Device TC22x/TC21x
Marking/Step ES-AC, AC
Package see Data Sheet

10310AERRA

This Errata Sheet describes the deviations from the current user documentation.

Figure 1 Example sequence showing how registers ETRRx may be filled with “Error Free” addresses

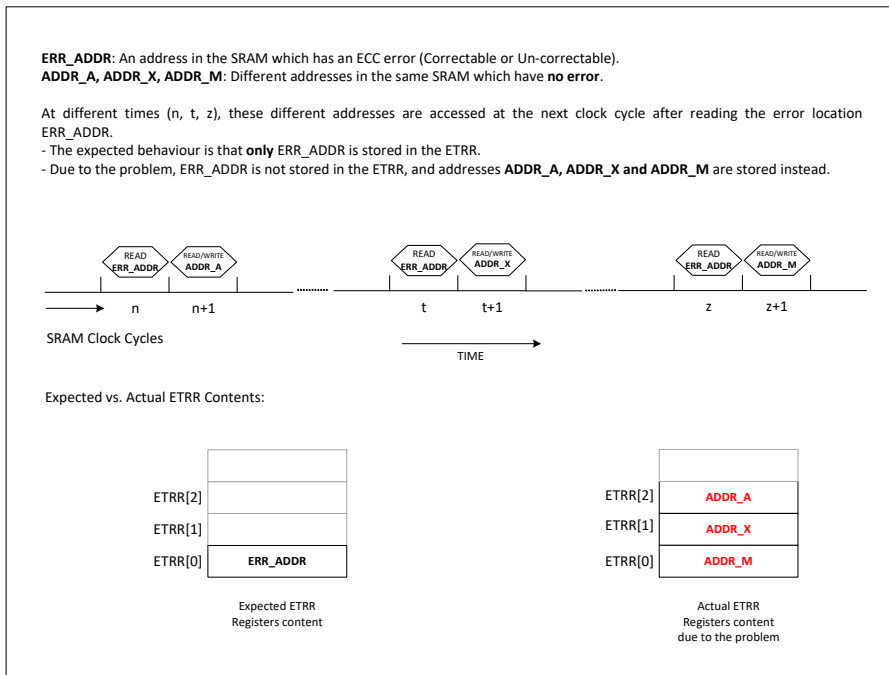
When such a consecutive access sequence (read from ERR_ADDR followed by read/write of different address(es)) happens multiple times, registers ETRRx

are filled with addresses that have actually no error – and the SRAM address which actually has an error is not stored indeed. **Figure 1** shows such an example scenario.

The consequence of the scenario explained in **Figure 1** is that a single error in the SRAM – example just one correctable error at a location ERR_ADDR – can result in registers ETRRx getting filled with fault-free address, and thus potentially even triggering an ETRR overflow.

2. Depending on the access sequences, an ETRR overflow might be triggered with one real error (e.g. correctable error) in the SRAM – consequence of the example shown in [Figure 1](#).

Figure 2 Recommended Software Handling - Flowchart

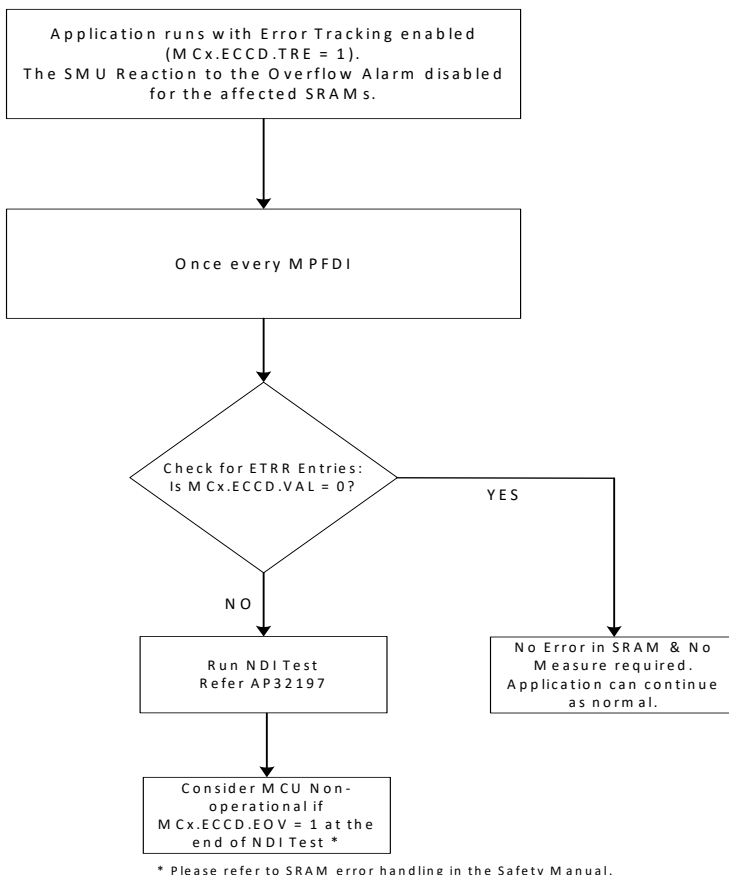
A flowchart of the recommended software handling is shown in [Figure 2](#).

If there is at least one valid ETRR entry (i.e. $MCx.ECCD.VAL \neq 0$) then the software shall run a Non-Destructive-Inversion (NDI) Test on the affected SRAM. Please refer to application note AP32197 (AURIX™ Memory tests using the MTU) for an example regarding running this test.

At the end of this test, if an ETRR overflow is detected ($MCx.ECCD.EOV = 1_B$) then the MCU shall be considered non-operational. Refer to section on Correctable SRAM Error handling in the Safety Manual.

Figure 8 Package Outlines TQFP-144 for TC22x/TC21x

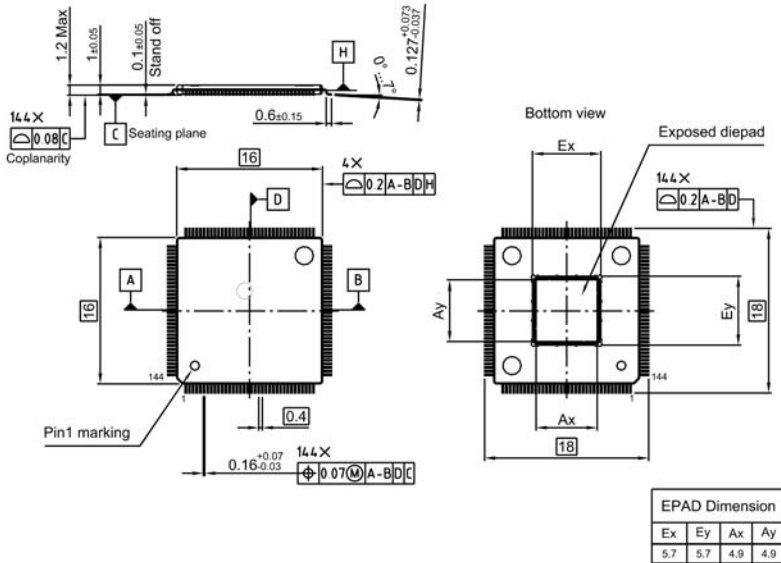
This information shall substitute the corresponding information in the TC22x/TC21x AC-step Data Sheet V1.0 and in the TC22x/TC21x A-step Data Sheet V1.0.

Note: For the exposed pad of the TQFP-144 package of the TC22x/TC21x, structural corner protrusions have to be considered for purposes of system design and integration with a maximum boundary of 6.2 mm.

Figure 9 Package Outlines TQFP-100 for TC22x/TC21x

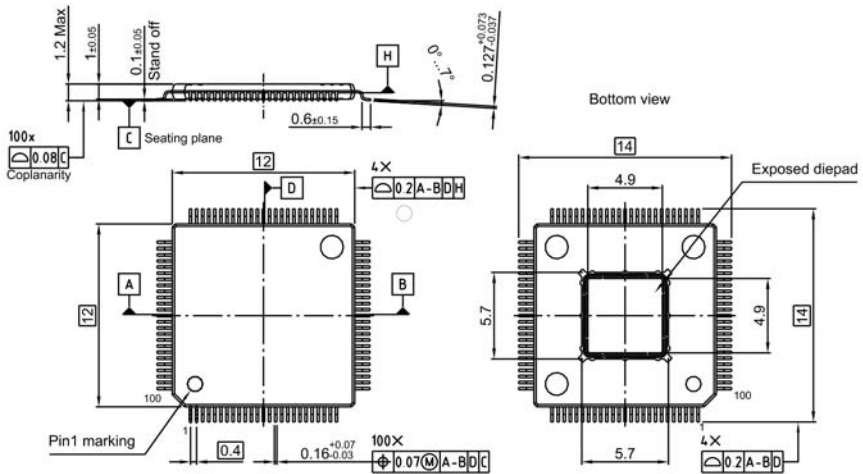
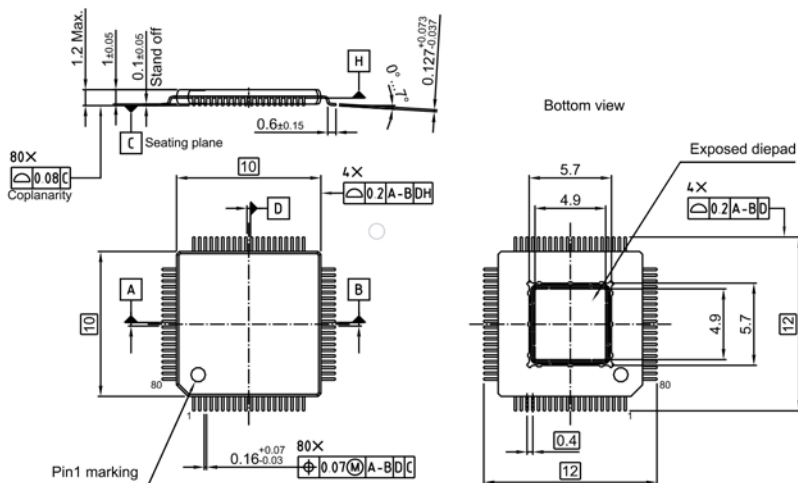
Note: For the exposed pad of the TQFP-100 package of the TC22x/TC21x, structural corner protrusions have to be considered for purposes of system design and integration with a maximum boundary of 6.3 mm.

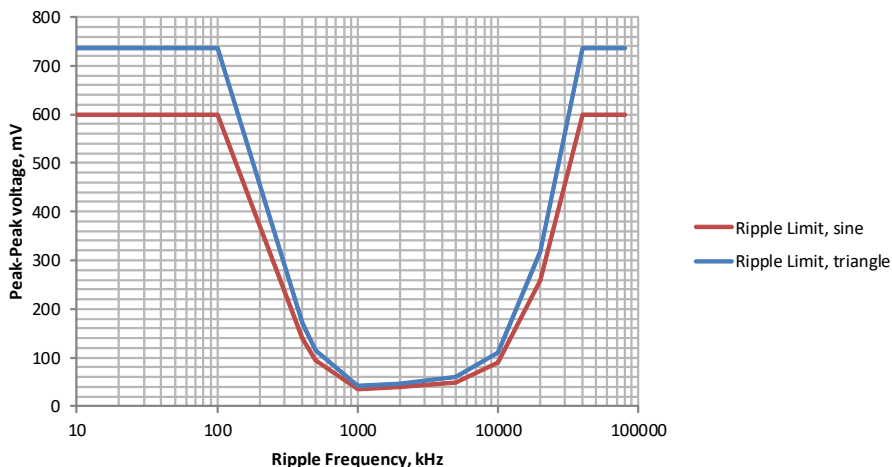
Wake-up timer usage with $\text{PMSWCR3.WUTDIV} = 1_{\text{B}}$ (10 ms count) for PMSWCR3.WUTREL values up to 20 ms is exposed to synchronization issues. The WUT counter PMSWUTCNT.WUTCNT is counted down to 0 every 10 ms, and reloading of WUTREL happens 10 ms later. If Standby request is sent before reloading PMSWCR3.WUTREL , regardless of $\text{PMSWSTATCLR.WUTWKPCLR}$, wake-up request is issued without counting down. This leads to immediate wake-up.

Use WUT with setting $\text{PMSWCR3.WUTDIV} = 1_{\text{B}}$ only for longer time periods (more than 20 ms).

For shorter periods the 10 μs clock should be used with setting $\text{PMSWCR3.WUTDIV} = 0_{\text{B}}$ (default after reset).

Figure 12 Short Serial Message, Serial Data Encoding over 16 messages

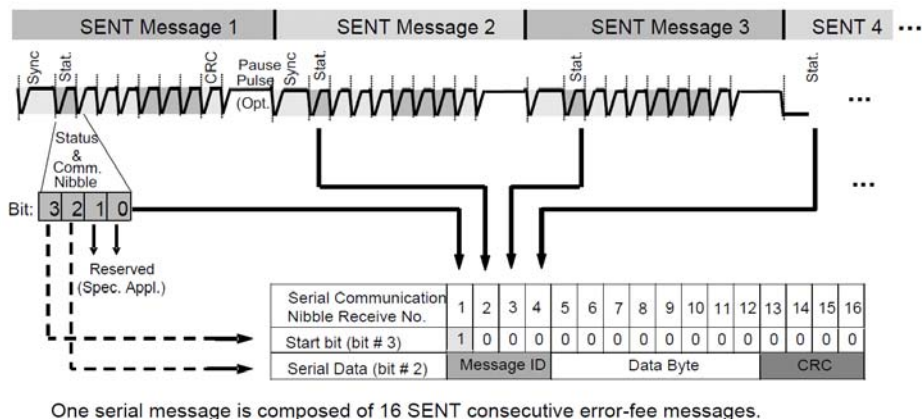
Figure 12 shows a corrected version of this figure.
